Product Conformance Statement

We Guangzhou Fantasia Creation Toys Co. Ltd., after the test from Bureau Veritas Consumer Products Services –Dongguan ,our product Rover Revolution was unqualified. The modification plan provided by **Bureau Veritas Shenzhen Co., Ltd., Dongguan Branch** engineer is as follows:

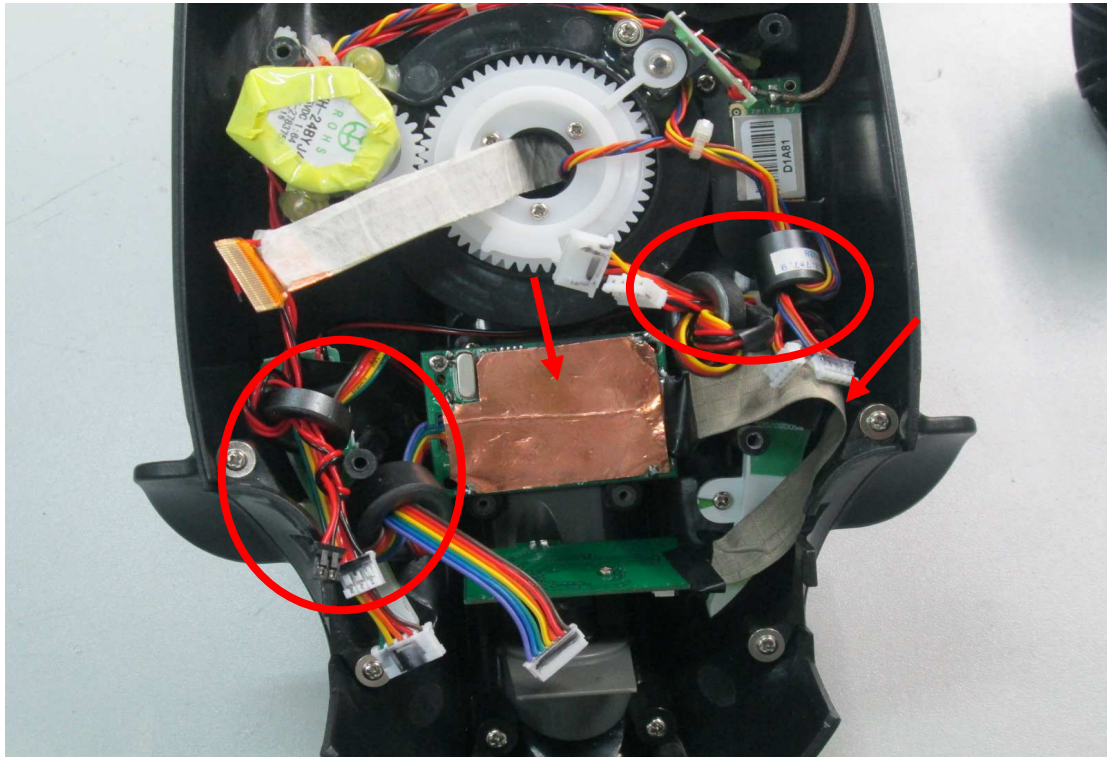
1. In the M1, M2, J10, J21, J7 port of power line, add a core and around 2 times, core model: T20*8*12; add a shielding on the main PCB.

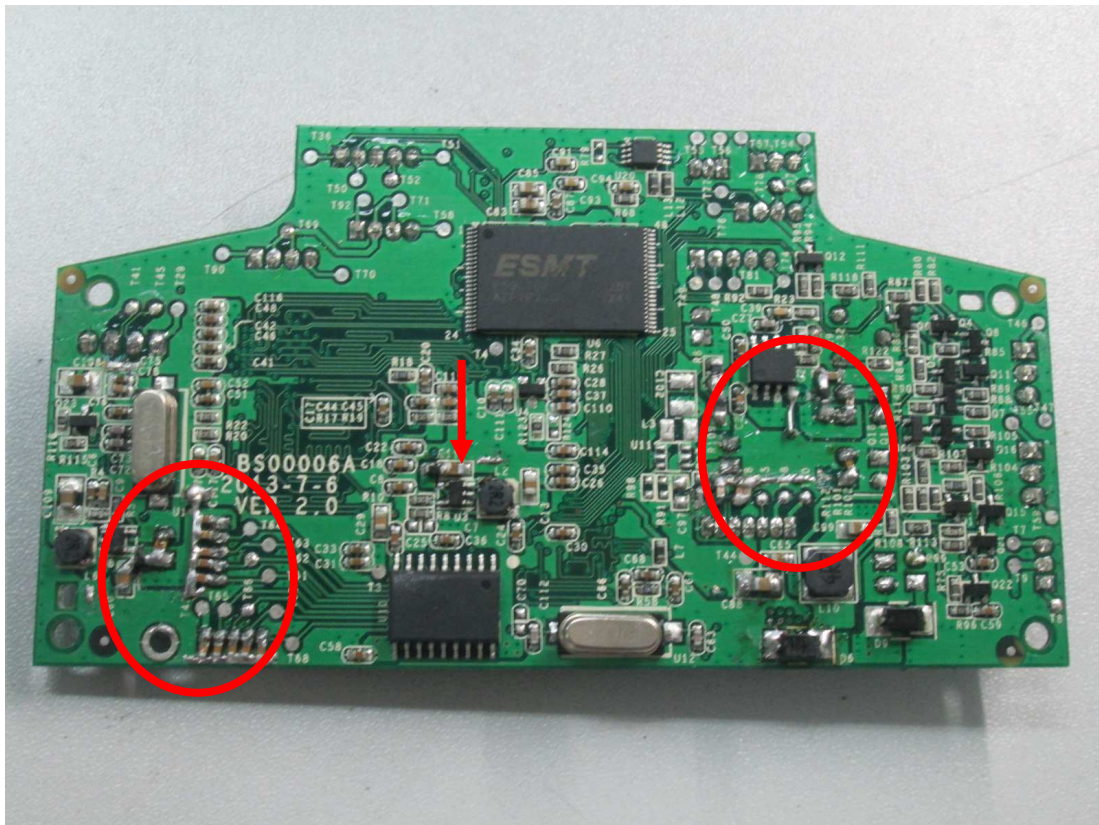
2. Two row line need shielding and grounding; In J5, J6 ports of cable add a core and around 2 times, core model: ; In J24, J20 ports of cable add a core and around 2 times, core model: T18*6*10; in J13, J22, J4 ports of cable add a core and around 2 times, core model: T18*6*10; In J11 port of cable add a core and around 3 times, core model: T18*6*10; add a shielding on the PCB.

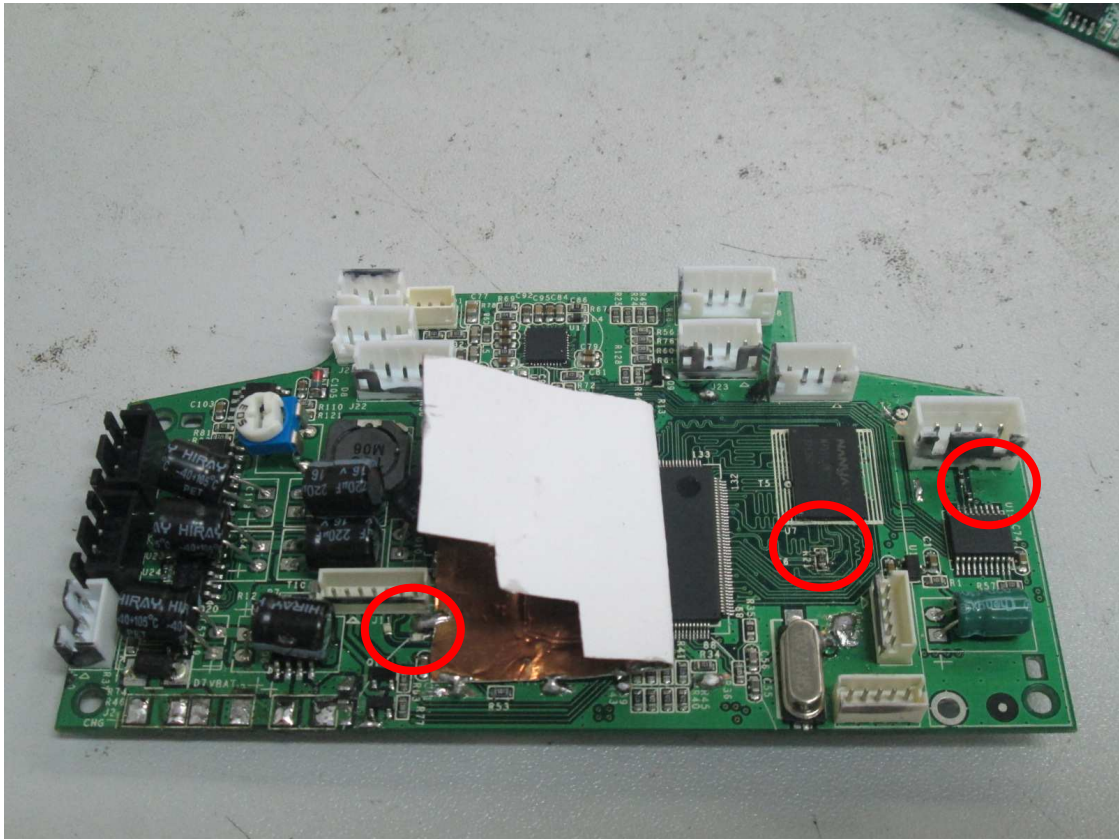
3. In C60, C11, C118, add a bead of 300 ohm @100M; in C54, C64, C119, C1118 add 104PF capacitor; in J5, D6 ports add 102PF of capacitor to GND; in J11 port add 10PF of capacitor to GND.

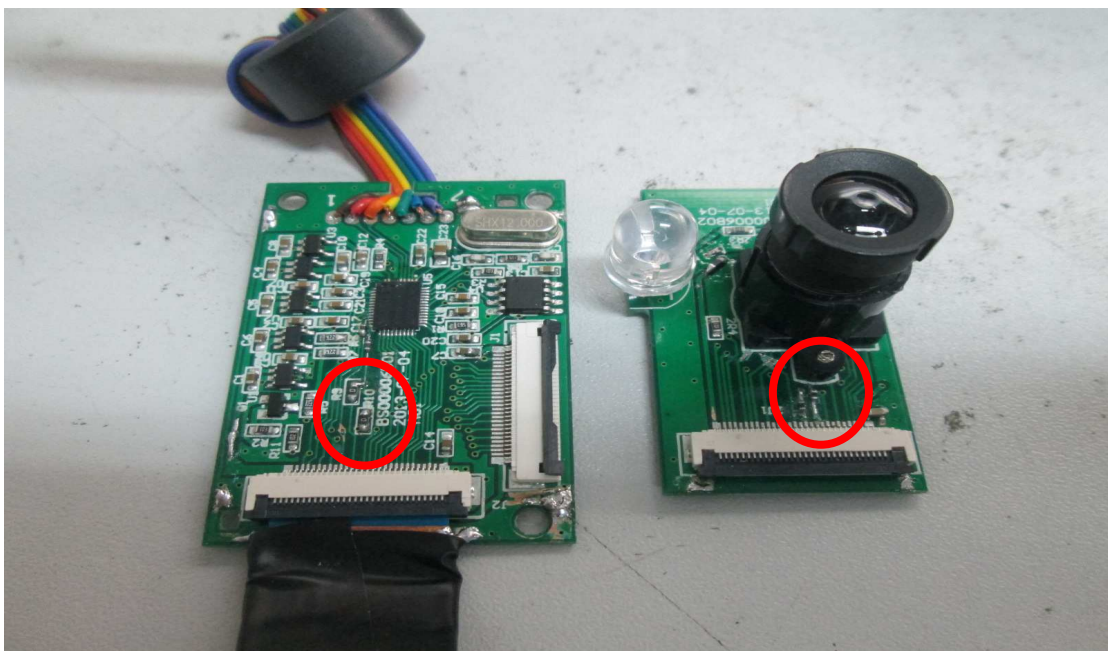
4. Connect R21 ends of signal line each add a 33 ohm resistor, in J11 , J20 of D+ D-, add a 60 ohm @100M bead.

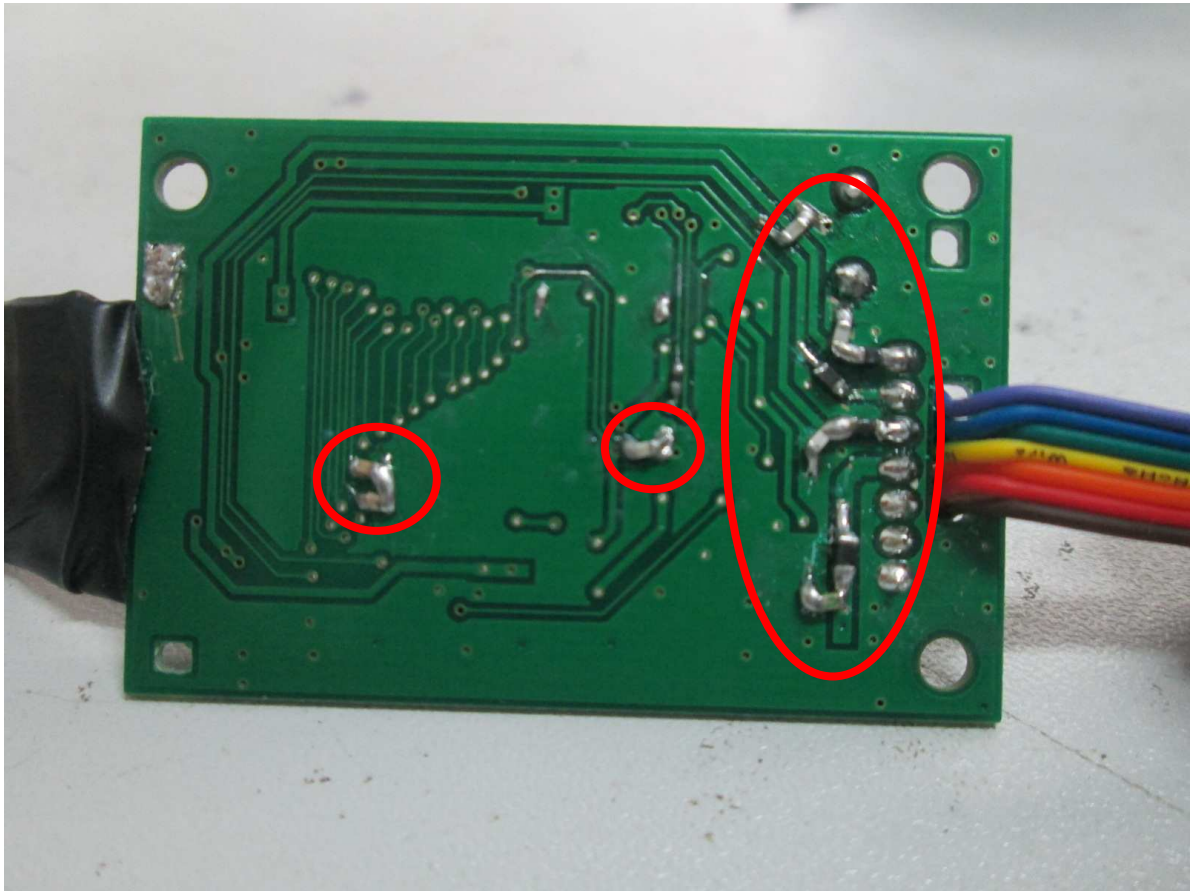
5. The R9, R10 changed to 0 ohm. in U5 ,the 21,23 pin each add a 600 ohm @100M bead and 10PF capacitors to GND; in J2, J3 of 29 pin add a 104PF capacitor, J1, J2 connected PCB board of 1pin and 15-23 pins add a 100.@100M bead.
